MR magnets & Superconducting magnets(QCS)

on behalf of the SuperKEKB magnet Group and QCS group

Unintended current reduction

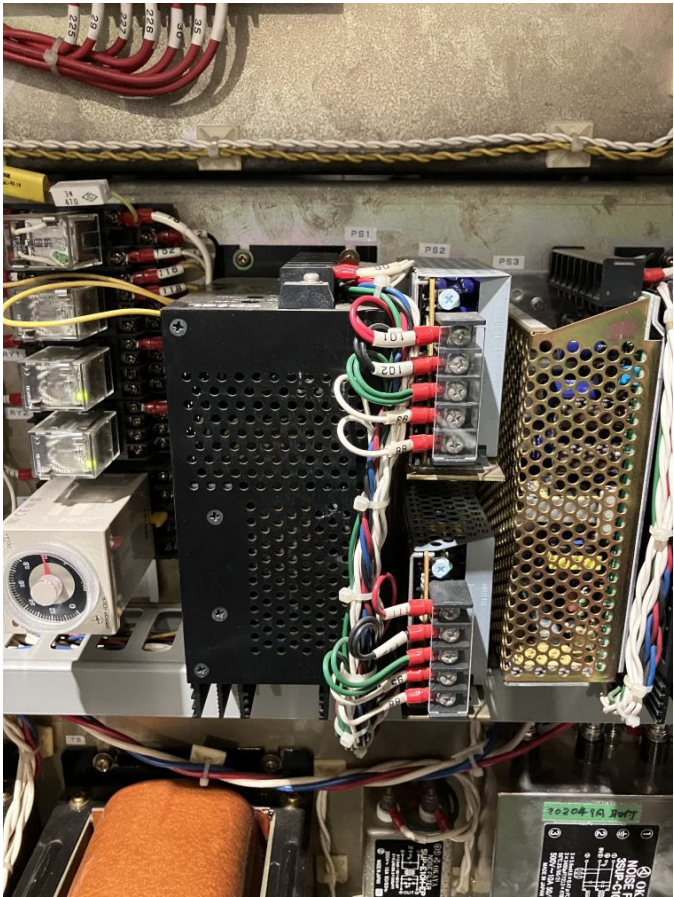
R18.1: Fix the power converter for QFROE_4.

⇒ Replace all control power supplies this winter.
As these delivery times take more than six months, we could not carry out the replacement last summer.

Reducing the use of LN₂: Thermal condition of QCS cryogenic system

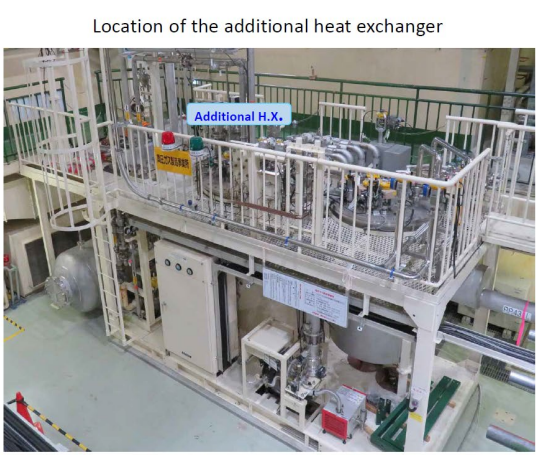
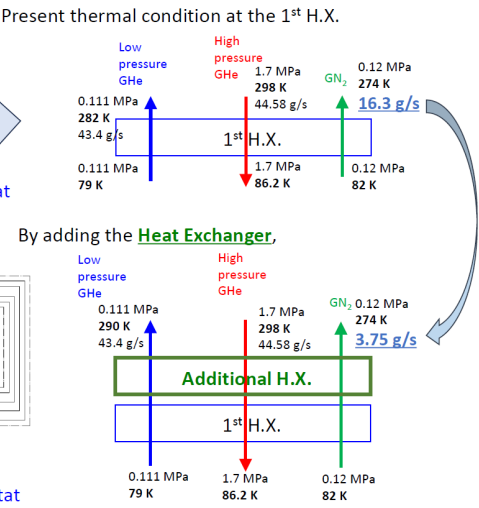
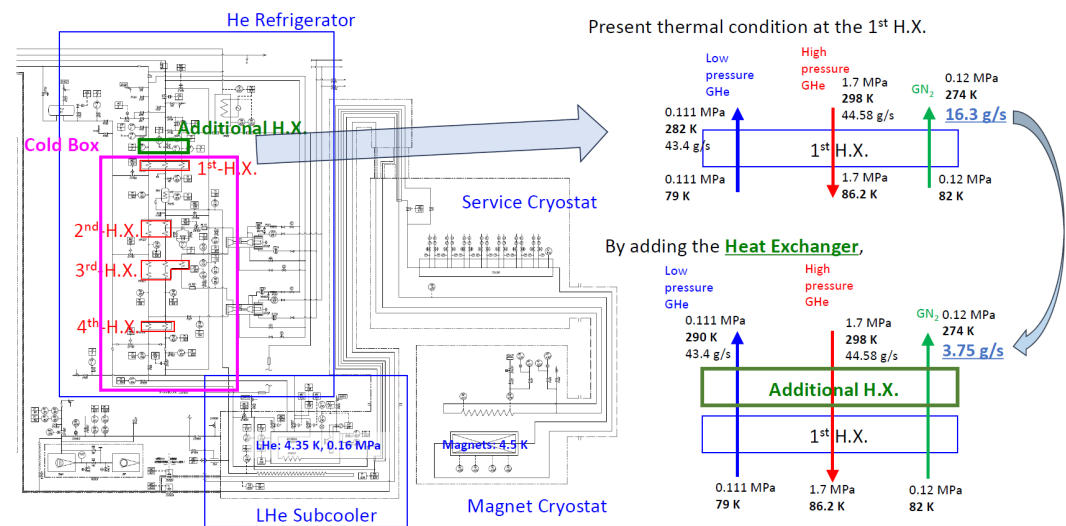
R19.1: Add a heat exchanger to reduce liquid nitrogen consumption as proposed.

⇒ The 0th heat exchanger will be installed as soon as possible.
